LAREDO SPRINGS  
 AMENDMENT TO  
 PRELIMINARY OVERALL DEVELOPMENT PLAN  
 #427-I

Re: Laredo Springs (Amendment)

MDP # 427-I

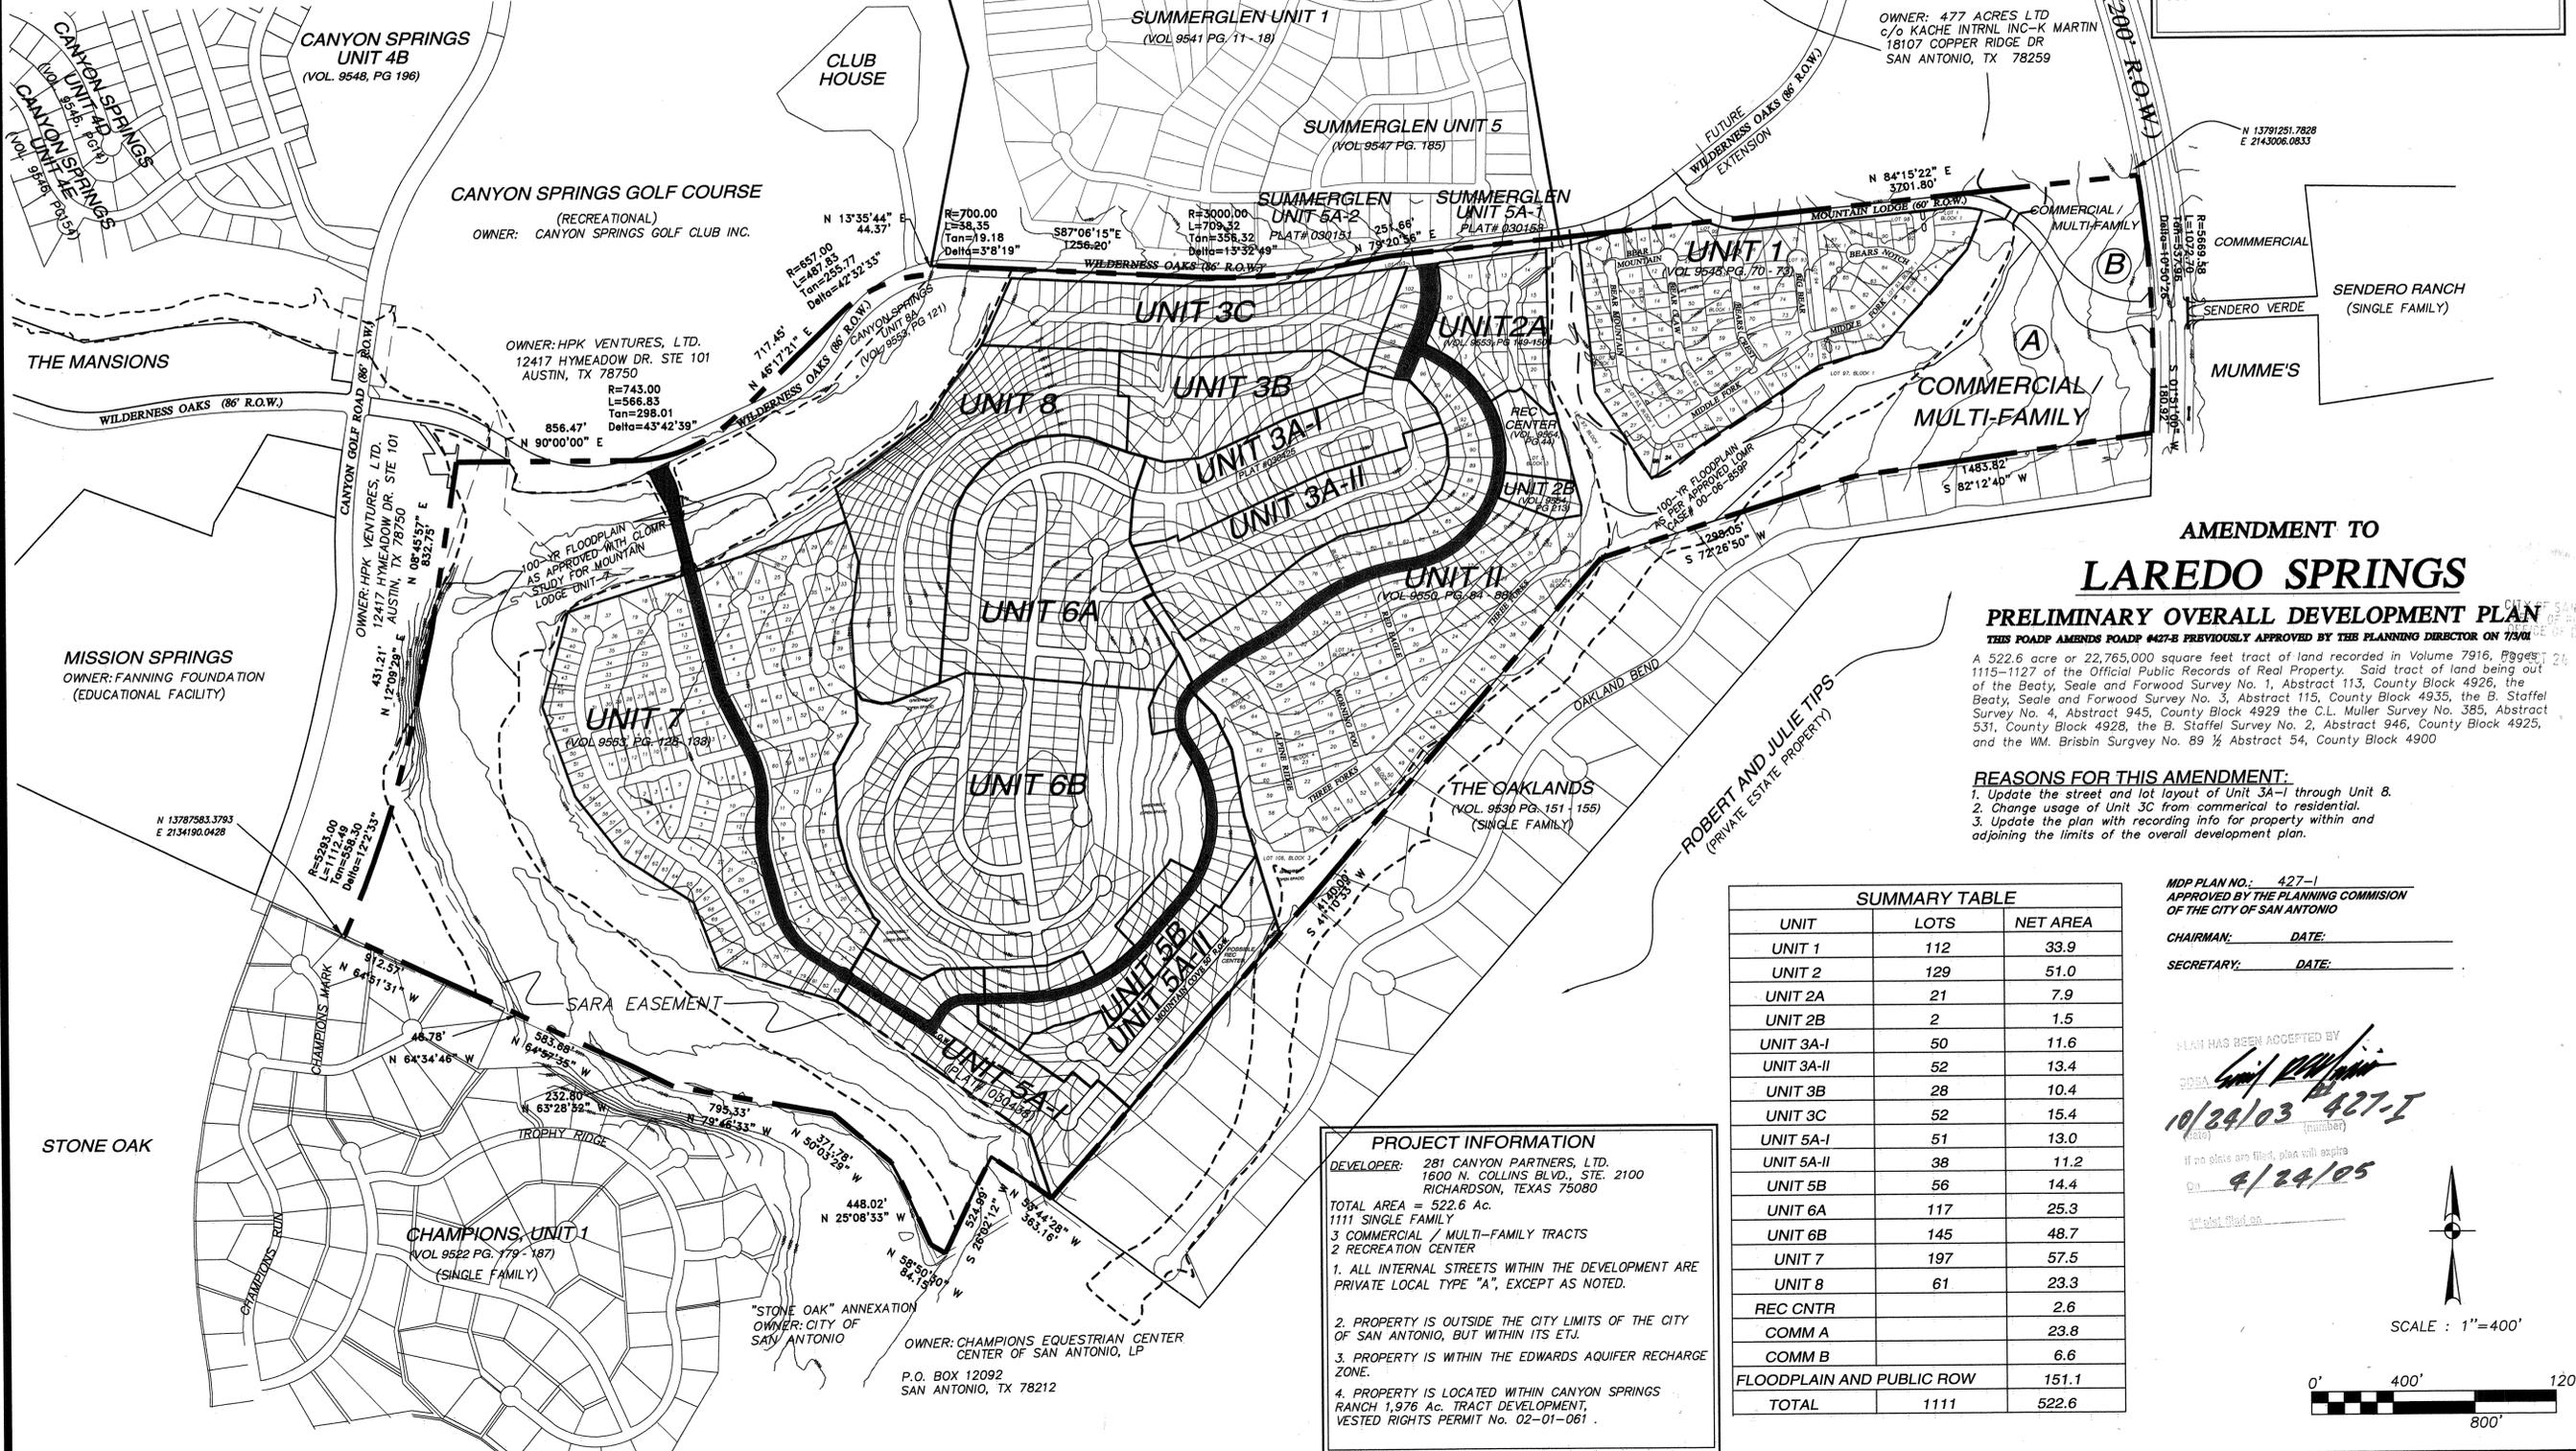
- In consideration of public safety and convenience, excessive grades by reason of topography should be avoided in street layouts and arrangements.
- Any access and R.O.W. issues along state facilities will need to be resolved with the Texas Department of Transportation (TXDOT). For information about these requirements you can contact TXDOT at 615-5814.
- This development will need to comply with tree preservation ordinance #85262. For information about these requirements you can contact Building Inspections at 207-7102.
- It will be expected that you will plat all of the property depicted in your Master Development Plan (M.D.P.) to include floodplains, drainage areas and open space.
- I would encourage you to work closely with the school district, so that they can plan accordingly.

This area is proposed to include 52 residential units. UDC Section 35-503 requires 1 acre of parkland for every 114 residential units. Laredo Springs, 427-I, has a 0.5-acre parkland dedication requirement.

The applicant has requested to pay the fee in-lieu of park dedication requirement based on the fair market value as set by the Bexar County Appraisal District. This fee is calculated to be \$8,460.68. This fee is to be paid in full to the Parks and Recreation Department prior to recordation of the first plat filed under this plan.
